**TOWN OF NEWBURGH
PLANNING BOARD
TECHNICAL REVIEW COMMENTS**

PROJECT NAME: FABULOUS EVENTS, INC.
PROJECT NO.: 22-23
PROJECT LOCATION: SECTION 34, BLOCK 2, LOT 25.2, 54, 76, 77
REVIEW DATE: 12 MAY 2023
MEETING DATE: 18 MAY 2023
PROJECT REPRESENTATIVE: LANC & TULLY – JOHN QUEENAN, P.E.

Re: Fabulous Events, Inc.
SBL: 34-2-25.2, 54, 76, 77
Site Plan – NYS Route 32

DEEP TEST RESULTS

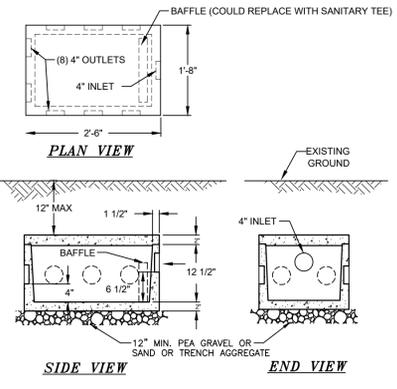
5. Results of deep test pits should be identified on the plans. Location of deep test and percolation testing should be depicted on the plan.
6. Pre-cast pump chamber detail should identify 1 ½ inch force main to distribution box to maintain positive slope.

SEPTIC PLAN
SCALE: 1"=20'

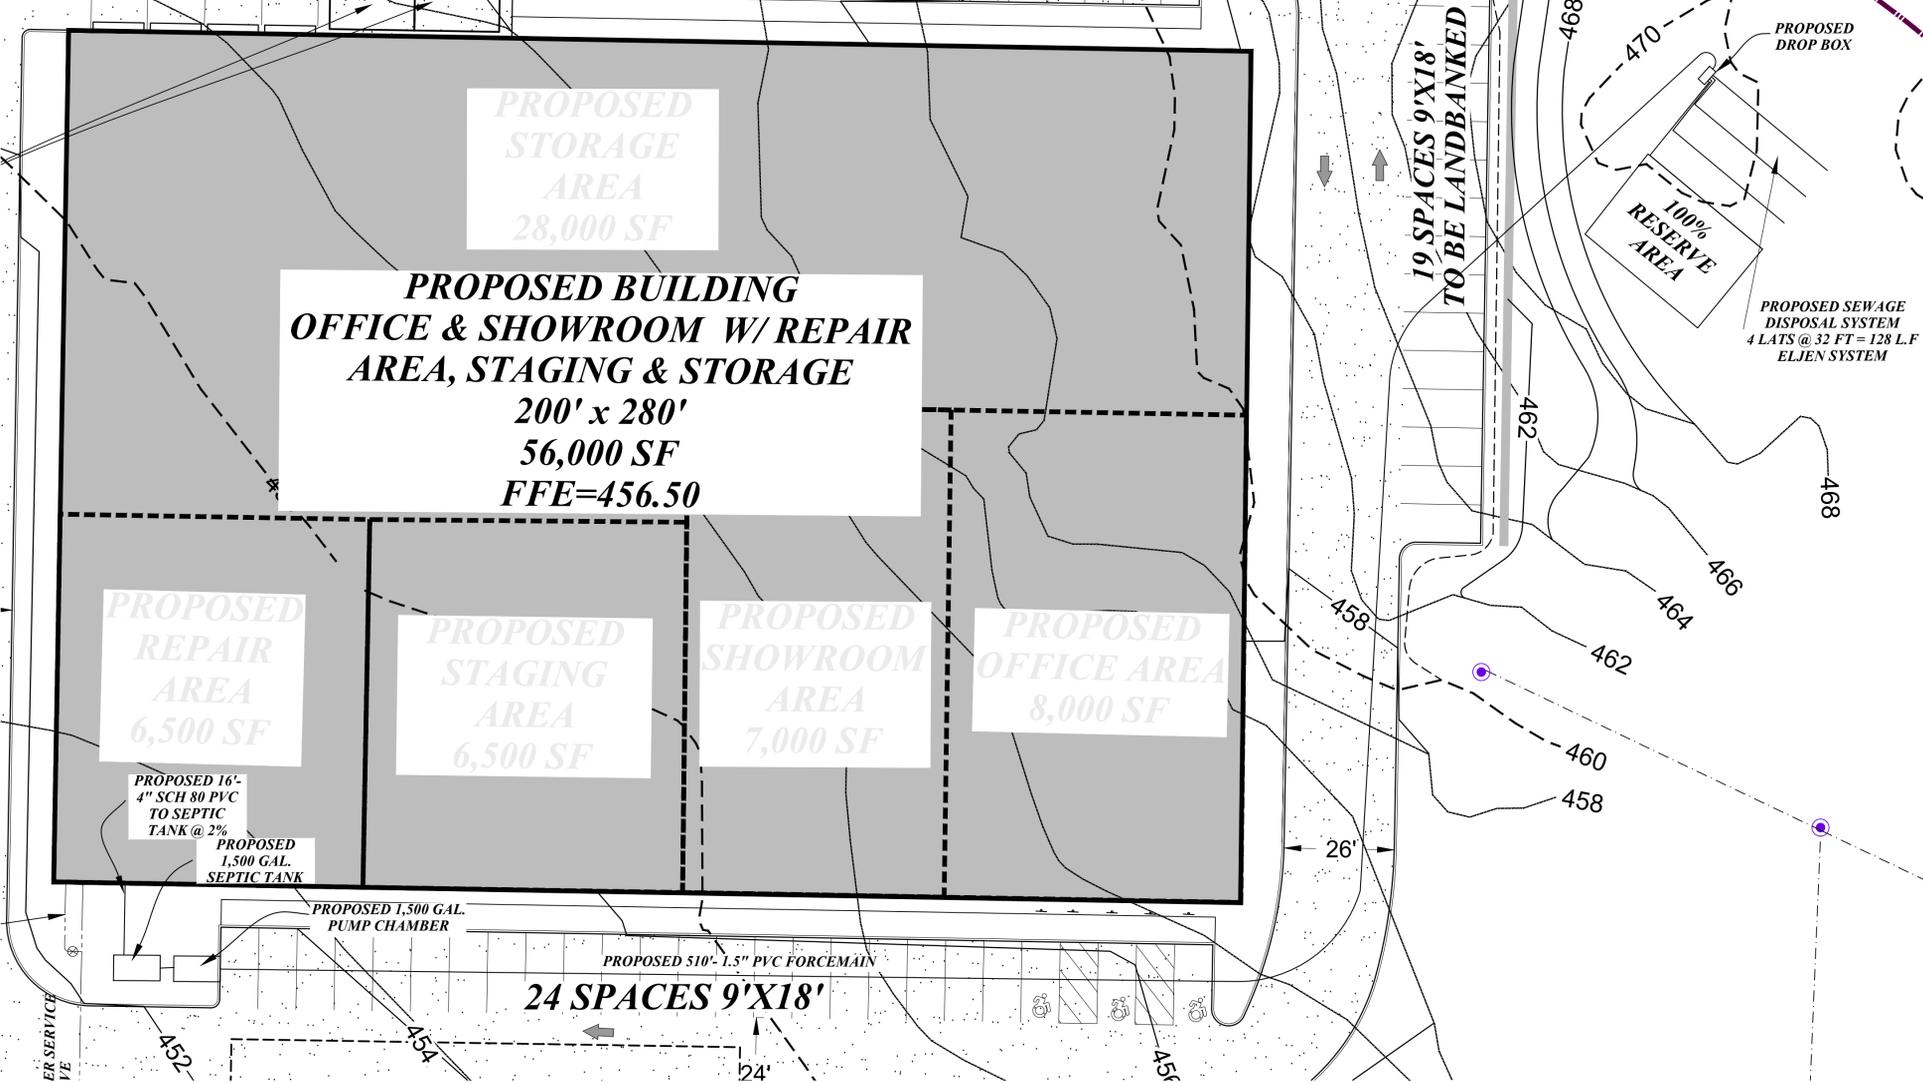
4. The subsurface sanitary sewer disposal system has been designed based on 18 employees and 10 customers per day at 15 gallons per day, per employee/customer. Use of the facilities should be restricted based on the subsurface sanitary sewer disposal system design to the 18 employees and max 10 customers. Any changes in the intensity of use may impact the subsurface sanitary sewer disposal system.

1. The location and size of the water service has been provided along with the standard Town notes and detail.
2. The design for the sewage disposal system has been depicted within the plan set.
3. The landscaping plan is being prepared and will be submitted within a future submission.
4. It is noted that the emergency access drive shall be gated.
5. A SWPPP will be submitted under separate cover.
6. The applicant will formally submit to the NYSDOT, now that the driveway location has been agreed upon. A copy of the submission will be provided to the Planning Board.

REFUSE STORAGE ENCLOSURE DETAIL
NOT TO SCALE

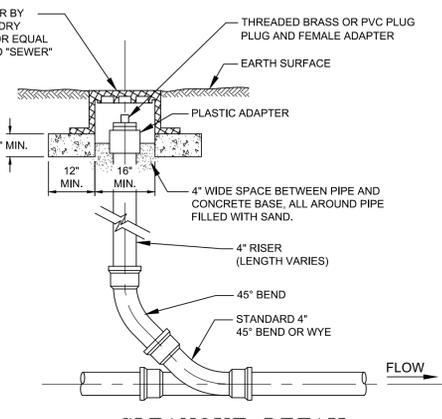
11. Code Department's comments regarding the refuse area abutting the rear structures should be received.
